PLYMOUTH HARBOR  
MASSACHUSETTS

DESIGN MEMORANDUM  
ON  
BREAKWATER AND ANCHORAGE

NEDED-R (8 Oct 65)

SUBJECT: Design Memorandum on Plymouth Harbor, Massachusetts

### SUMMARY OF STABILITY ANALYSIS AND TYPICAL WEDGE ANALYSIS

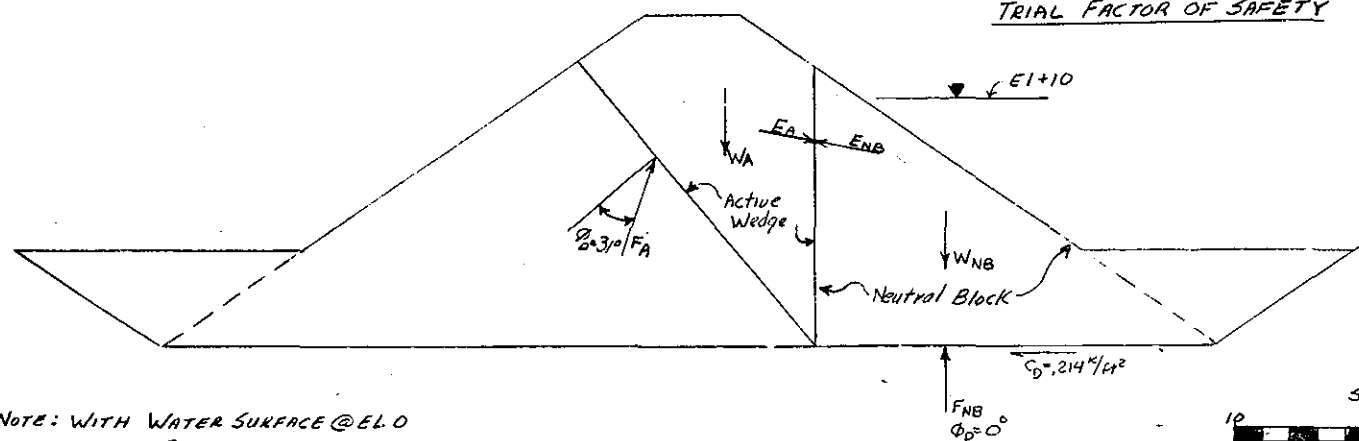
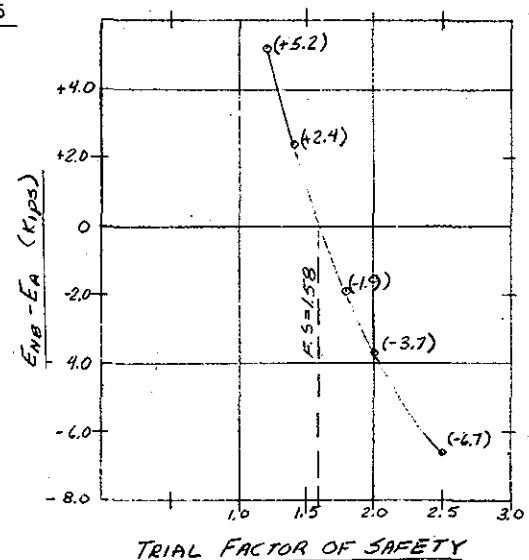
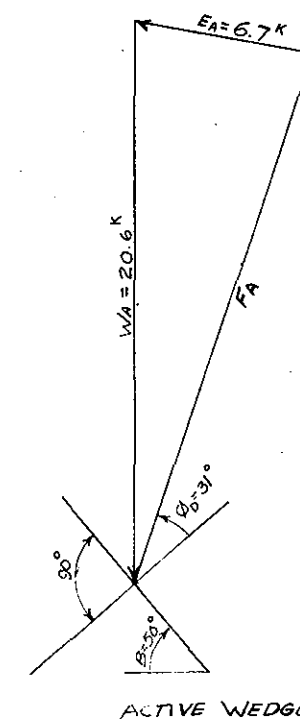
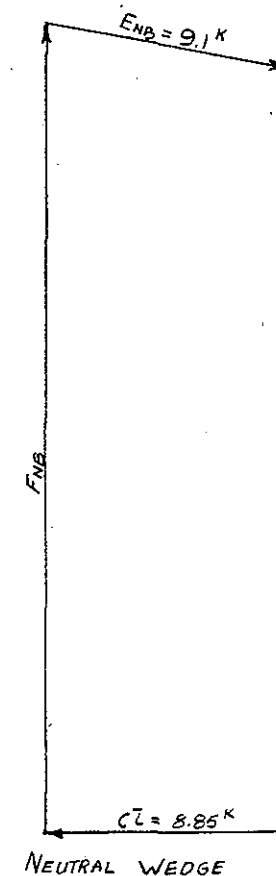
1. Re: Paragraph a. The requested stability studies are shown on Plates Nos. A-1 through A-4 included in the accompanying copies of the revised Design Memorandum. These studies were made on a typical section having a bottom elevation of -8.0, since it is likely that this section will result from overdepth dredging, and settlement and displacement of the underlying foundation materials during construction of the breakwater. The shear strength of the underlying foundation soils as used in the studies was determined from laboratory tests on undisturbed samples obtained from foundation boring FD-13. Results of shear and consolidation tests are shown on Plates Nos. A-5 through A-8, included in the accompanying copies of the revised Design Memorandum.

2. As shown by the analyses, the minimum factors of safety obtained are 1.5 by the wedge method of analysis and 1.45 by the circular arc method. These values are considered satisfactory. Analyses for the case of bottom elevation at -5.0 m. l. w. indicate higher factors of safety.

FAILURE SURFACE	FACTOR OF SAFETY
A-1	1.9
A-2	1.7
A-3	1.5
A-4	1.5
